Modification Available Performance Enhancement Service Note

N1060A Precision Waveform Analyzer

Serial Numbers: US00000000-US63030100, MY00000000-MY63030100

A hardware upgrade is available which may improve 12-Edge Output Jitter EOJ measurement repeatability for some devices.

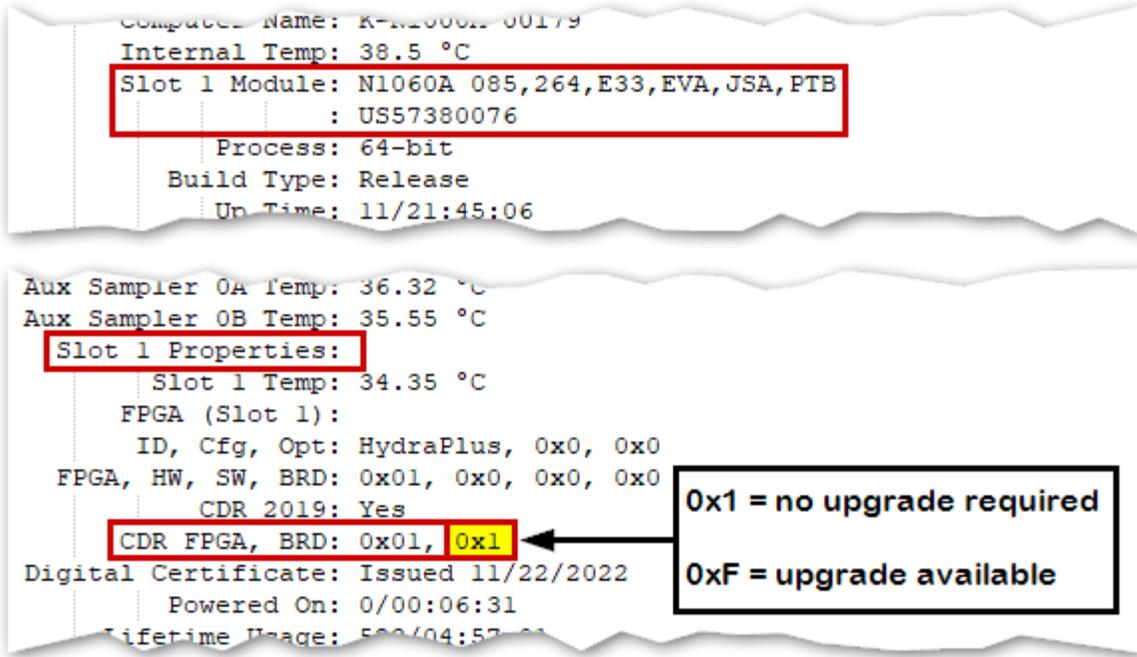
The degree to which the bi-modal distribution is present, if present at all, is highly dependent on the signal under test. Likewise, the degree of improvement which may be obtained from this upgrade is also highly signal dependent. For some devices, it is possible that no improvement will be observed.

Keysight strongly recommends evaluating a new-design N1060A WITH YOUR DEVICE before sending units for upgrade. Contact your Keysight representative to arrange for evaluation.
